ON-SITE SEWAGE DISPOSAL SYSTEM HOWARD COUNTY HEALTH DEPARTMENT BUREAU OF ENVIRONMENTAL HEALTH

SUBDIVISION: Windridge Farms LOT NUMBER: 23

ADDRESS: 14517 Windridge Court PROPERTY OWNER: Hamilton Reed

HOUSE LOCATION
DRAWING

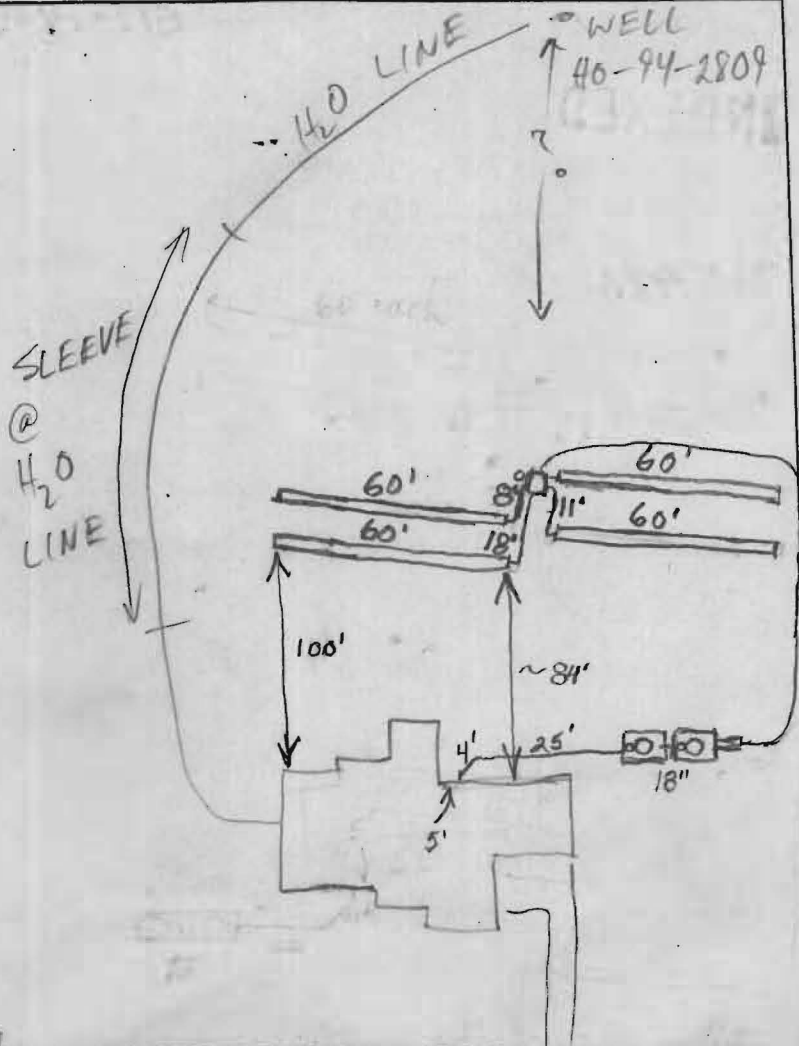
9/13/01 INSP MISSED-CONTRACTOR REPORTS SRA NOT STAKED-BLDR TOLD
PRE-CONSTRUCTION INSPECTION: TO RE-STAKE, OK TO REVERSE H2O LINE AND
PRESSURE SEWER LINE (MR) 9/14/01 OK TO START (4) 60' TRENCHES AS PER PLAN (MR)

INSPECTION COMMENTS: 9/17/01 OK TO COVER FIRST (3) TRENCHES, CONTINUE (MR)
9/18/01 O.K. to cover everything. Need pump and alarm test for final
approval. (BB) 11/21/01 Pump and alarm working. (BB)

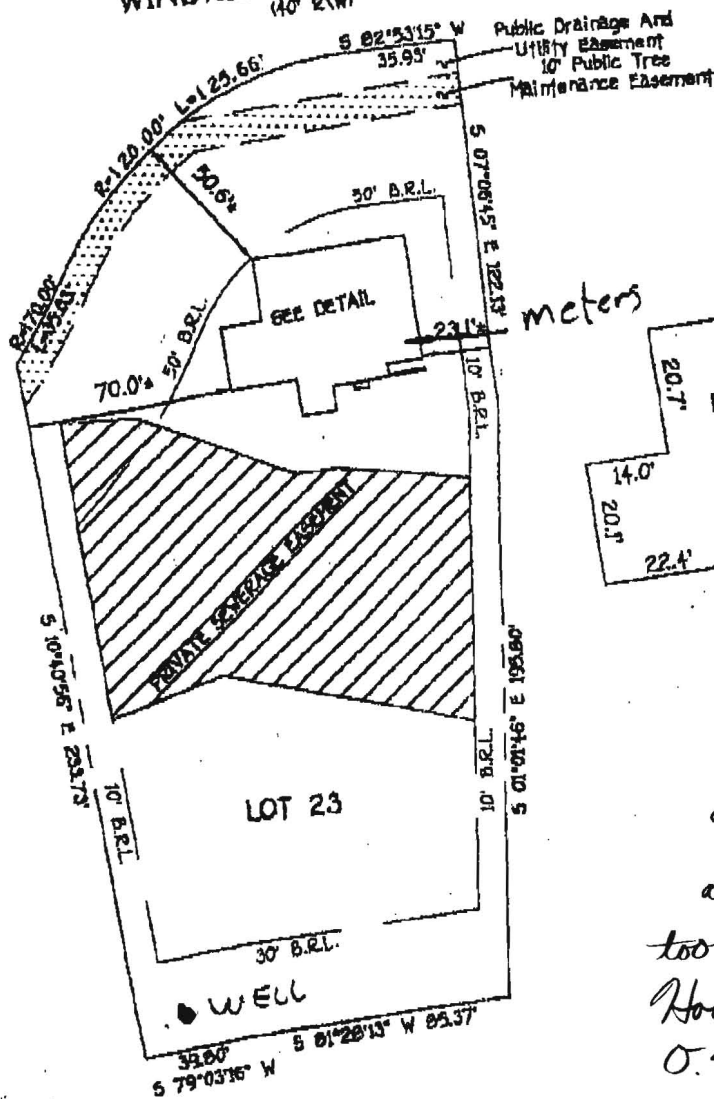
9/4/01 House location
as per B.P. plan. Approved
too close to septic easement.
However minimal impact.
O.K. *BR*
